Site Address: 190 EASTBROOK WY SAC
Parcel No: 201-0370-027 LOT 27 NORTHBOROUGH 3-1

Nature of Work: MP 2301 2 STORY 8 ROOM SFR

LOT 27 PLAN 2301 NATOMAS (JOB # US279)

IT IS O.K. TO DRILL/CUT HOLES IN THE 14" / 250
FLOOR JOISTS ON THE ABOVE NOTED PLAN AT THE
LOCATIONS SHOWN ON THE FOLLOWING DRAWINGS.

Lot #27
2301 PLAN

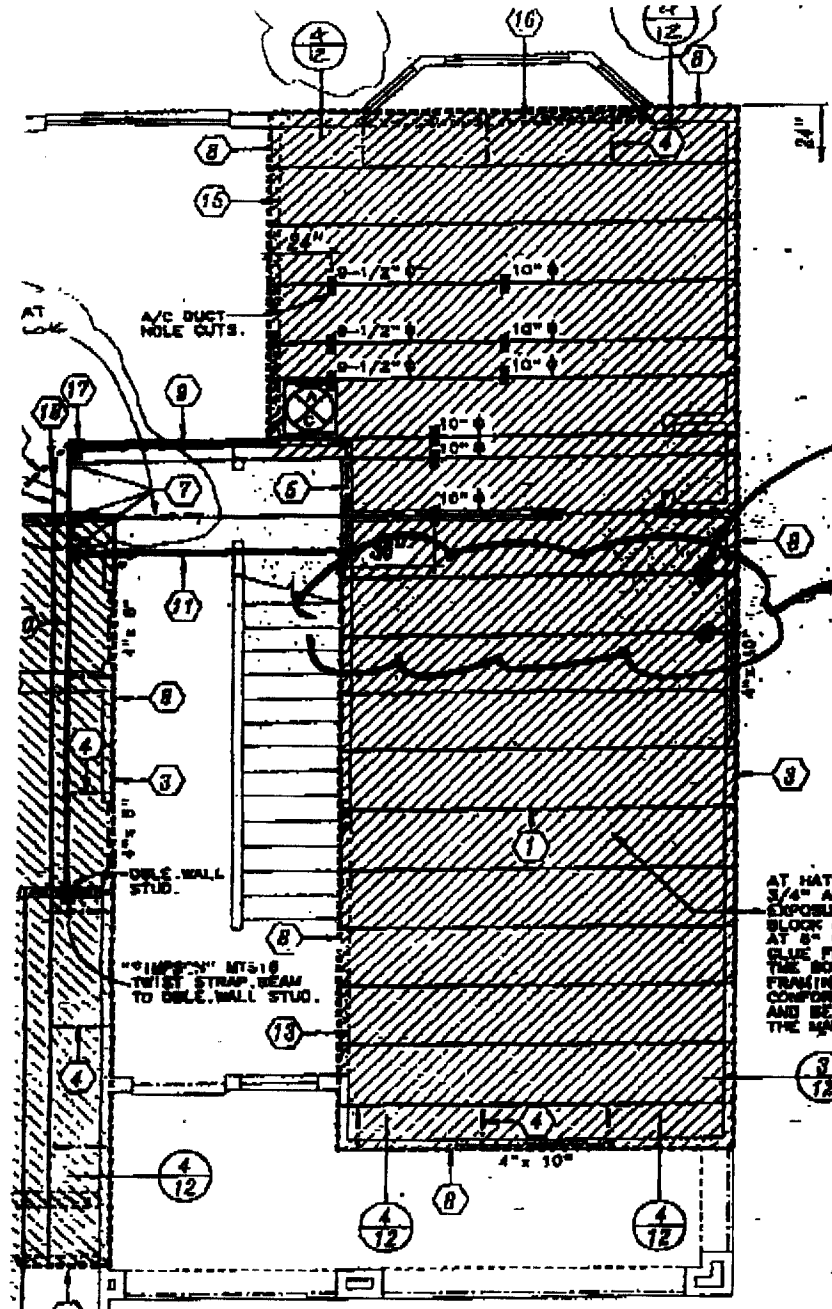
5" SQUARE HOLE 1'-6" FROM PLATE
JOIST #1

STRAP REQUIREMENTS FOR 14 1/2" PLATE BREAKS AT DUCT PENETRATION

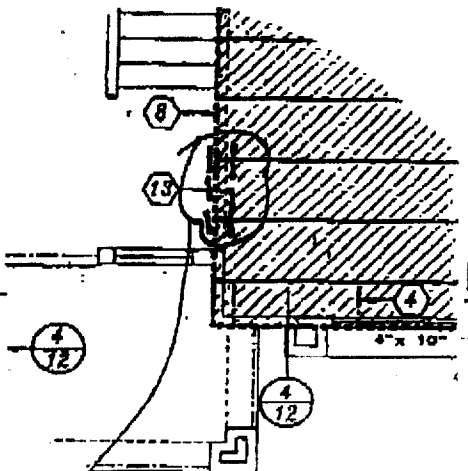
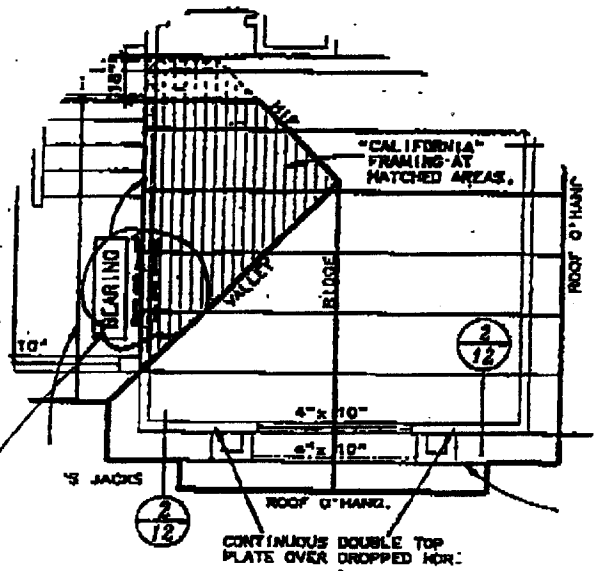
36" LONG C616 STRAP
 EACH FACE OF BOTTOM
 PLATE - CENTRAL
 STRAPS AT CENTRAL
 OF PLATE BREAK.

SIMPSON MST37 STRAP
 BACK FACE OF DOUBLE
 TOP PLATES - CENTRAL STRAPS
 AT CENTRAL OF PLATE BREAK

PROVIDE STUD/BLOCKING AT EACH END OF
 PLATE BREAKS TYP.

2/
Lot #27
2301 PLAN

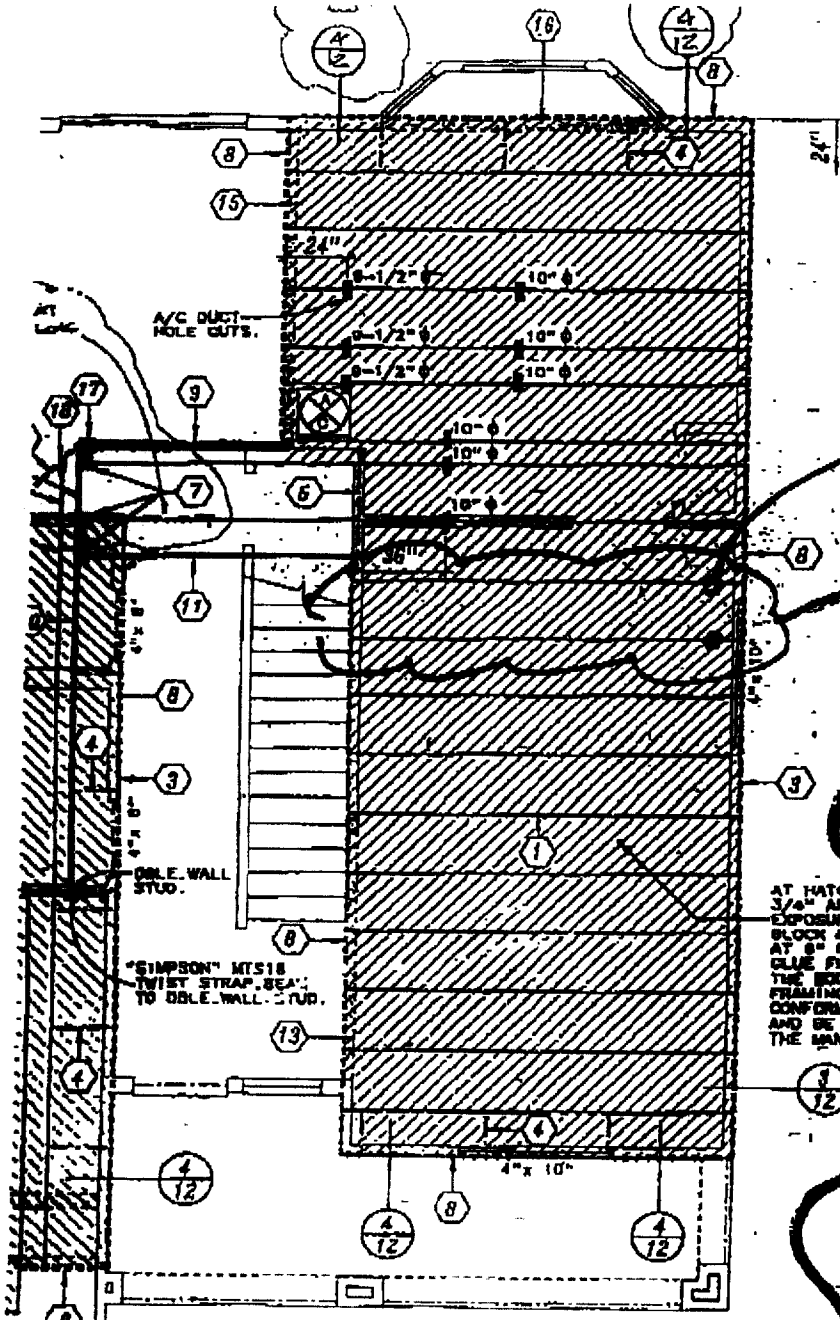
5" SQUARE
HOLE 1'-6"
FROM PLATE
JOIST #1

1'-3" TO
START OF CUT

O.K.
REVISED
11-6-00

Lot #27
2301 PLAN

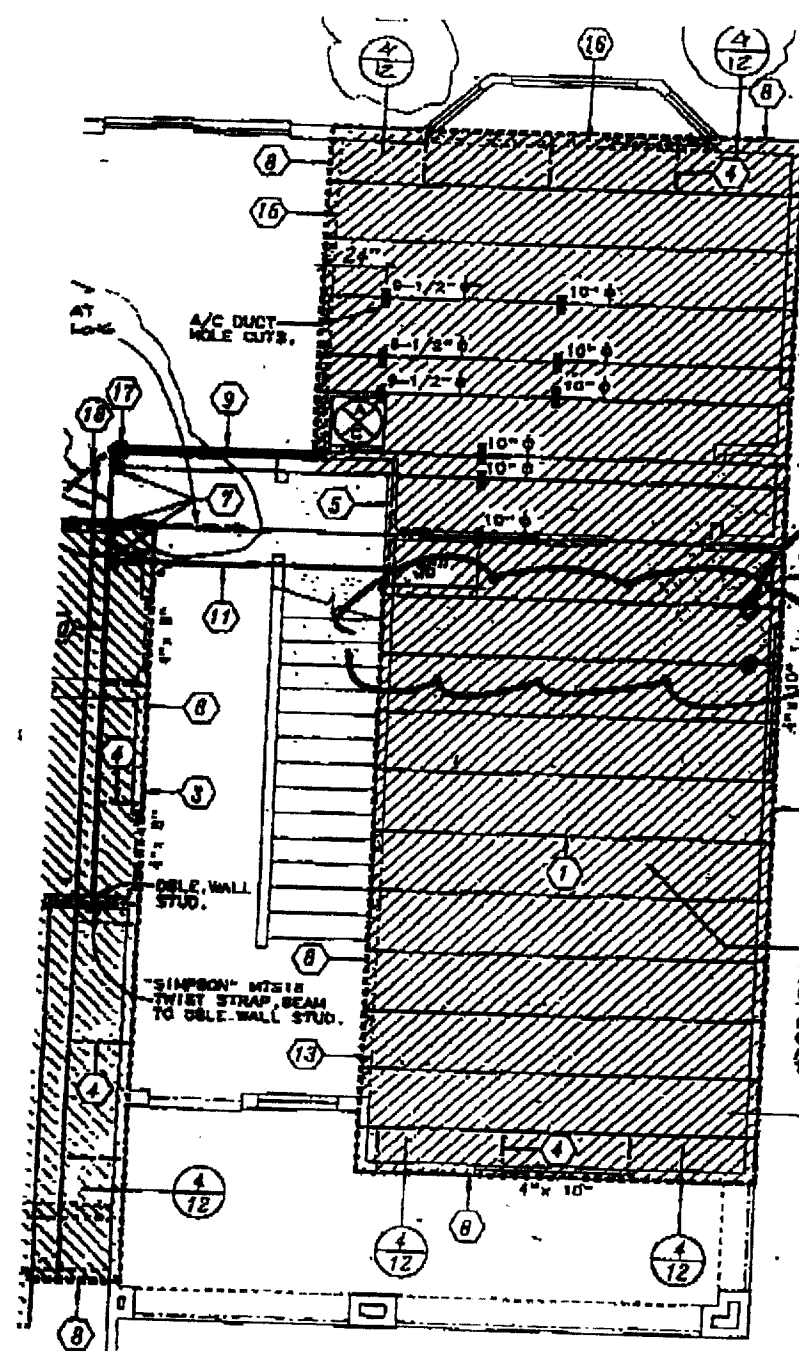
5" SQUARE HOLE 1'-6" FROM PLATE JOIST #1

1'-3" TO START OF CUT

O.K. TO BE 9" FROM INSIDE FACE OF WALL TO START OF CUT

O.K. REVISED 11-6-00

REVISED 11-7-00

14" TJI®/Pro™-250 JOIST @ 24.0" o/c

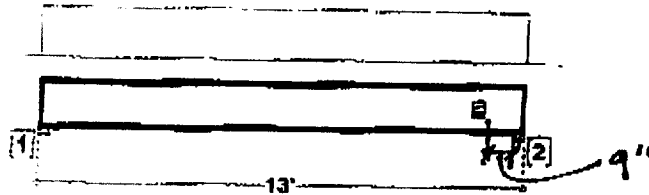
9" TO START OF CUT FROM INSIDE FACE OF WALL
